Access Compliance Report

Public Rights-of-Way

(Curb Ramps)

Intersection ID: 2527	Main Street: CAMBRIDGE_BAY_DR	Cross Street: LAGRANDE_DR	Location: SW
ADA ID: 6303A67320C3	Ramp Type: PerpDiag	Initial Pass/Fail: Pass	Overall Compliance: No
Severity Score: 0			
Codes/Mitigation Info/Possible Solution		Field Measurements/Component Compliance

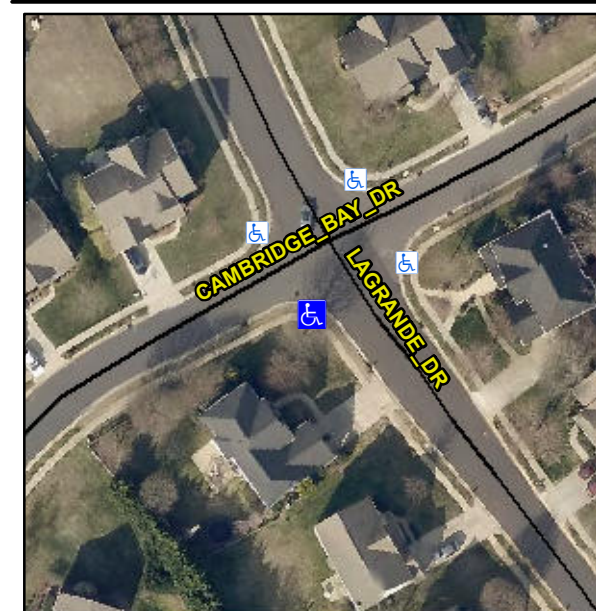
R304.2.2-Perp, R304.3.2-Para, R304.5.3, R305.2

Compliance	Description	Data	Compliance	Description	Data
N/A	Ramp Length (in)	47.0	Yes	Ramp Slope (%)	6.0
Yes	Ramp Width (in)	48.0	Yes	Ramp XSlope (%)	1.8
N/A	Flare Type LT	Sloped	N/A	Flare Type RT	N/A
N/A	Flare Slope LT (%)	9.8	N/A	Flare Slope RT (%)	2.7
N/A	Flare Traversable LT?	No	N/A	Flare Traversable RT?	No
Yes	Landing Length (in)	48.0	Yes	DWS Provided?	Yes
Yes	Landing Width (in)	48.0	Yes	DWS Contrast?	Yes
No	Landing Slope (%)	3.3	Yes	DWS Length (in)	24.0
No	Landing X Slope (%)	3.7	Yes	DWS Full Width?	Yes
N/A	Landing Curb? (Y/N)	No	No	DWS Offset (in)	4.0
N/A	Shared Landing?	No			
Yes	Gutter Ponding?	No	Yes	Gutter Slope (%)	2.2
Yes	Gutter Lip Ht (in)	0.0	No	Gutter X Slope (%)	3.1
N/A	Painted X Walk1?	No	N/A	Painted X Walk2?	No
	X Walk 1 Direction	To E		X Walk 2 Direction	To N
N/A	X Walk 1 Width (in)	N/A	N/A	X Walk 2 Width (in)	N/A
	X Walk 1 Slope (%)	4.3		X Walk 2 Slope (%)	1.7
	X Walk 1 X Slope (%)	0.1		X Walk 2 X Slope (%)	2.8

N/A	Ramp inside XWalk1?	N/A	N/A	Ramp inside XWalk2?	N/A
	Road Slope (%)	1.6	N/A	Clear Space?	Yes
	Road X Slope (%)	2.6	N/A	Clear Space to XWalk (in)	N/A
Yes	Any Obstructions?	No	Yes	Storm Grate/Utility Hazard?	No
	Obstruction Type			Storm Grate/Utility Type	
		N/A			N/A
			Yes	Surface Condition? (G/P)	Good

Remove & Replace Curb Ramp With Two New Directional Ramps or Equivalent. Remove & Replace Gutter.
